SUNDRY NOTICES AND REPORTS ON WELLS

East Turkey Track Fed Com #4

Plug back from Wolfcamp Perfs (9506-40') and set CIBP @ 9450' w/ 50' cement.
Attempt completion in the Lower 2nd Bone Spring sand (7930-8076').

**East Turkey Track Fed Com #4
30-015-31632
MYCO Industries Inc.
March 2, 2010
Conditions of Approval**

EAST TURKEY TRACK FED COM #4-P

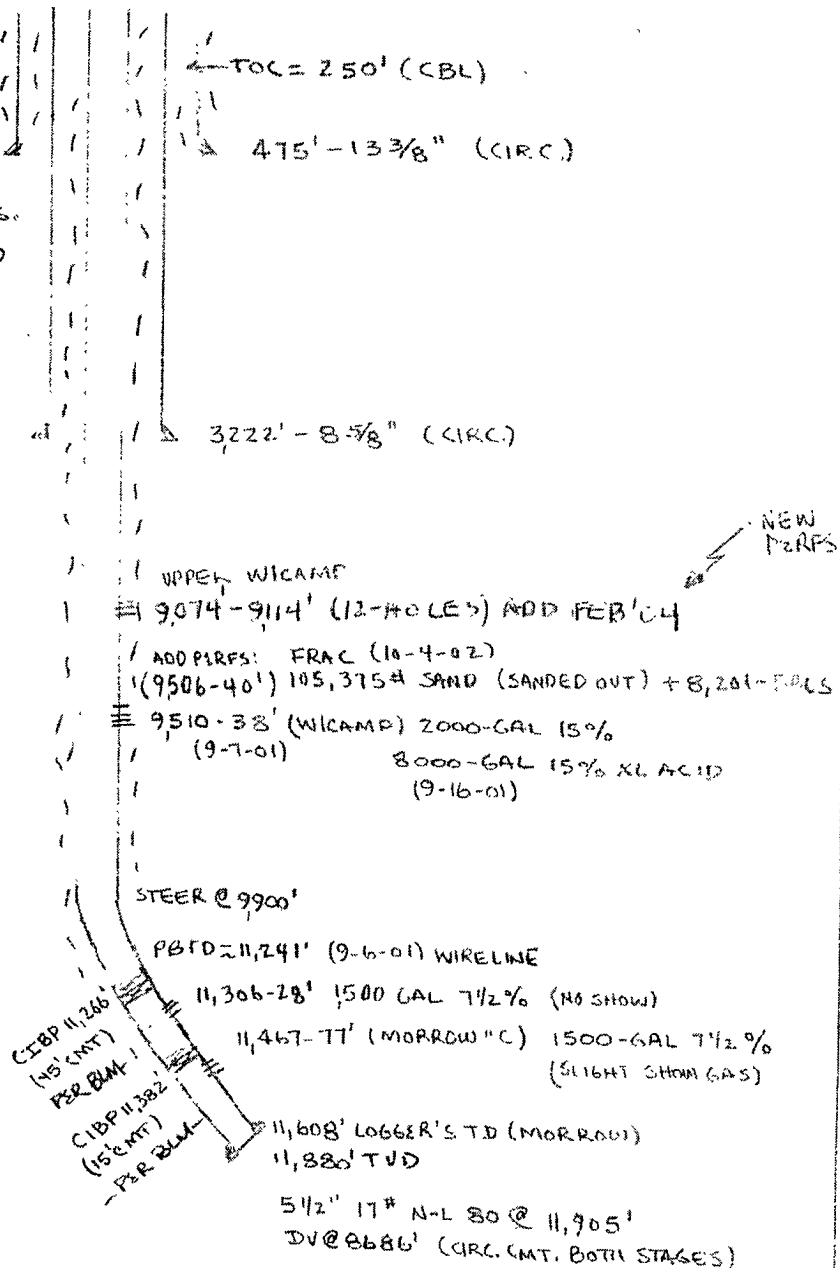
- 1. Contact BLM 575-361-2822 a minimum of 4 hours prior to tag of CIBP at 11,266'.**
- 2. A minimum of a 3M BOP is required and must be tested prior to performing operations. All blowout preventer (BOP) and related equipment (BOPE) shall comply with well control requirements as described in Onshore Oil and Gas Order No. 2 and API RP 53 Sec. 17.**

- 3. Tag CIBP at 11,266' and bail 35' of cmt or spot 25 sxs on top of bridge plug.**
- 4. A 200' plug (minimum 25 sxs class H) must be set across the top of the Morrow from 10,900'-10,700'. (Top of Morrow 10,850')**

- 5. A 190' plug (minimum 25 sxs class H) must be set across the top of the Wolfcamp from 9,119'-8,919'. WOC and Tag no shallower than 8,919'. (Top of Wolfcamp 9,069')**

- 6. Either 190' plug must be set across the DV tool from 8736'-8546' or the previous Wolfcamp plug can be extended to bring the plug 50' above the DV tool. WOC and Tag plug. (DV tool at 8,686')**
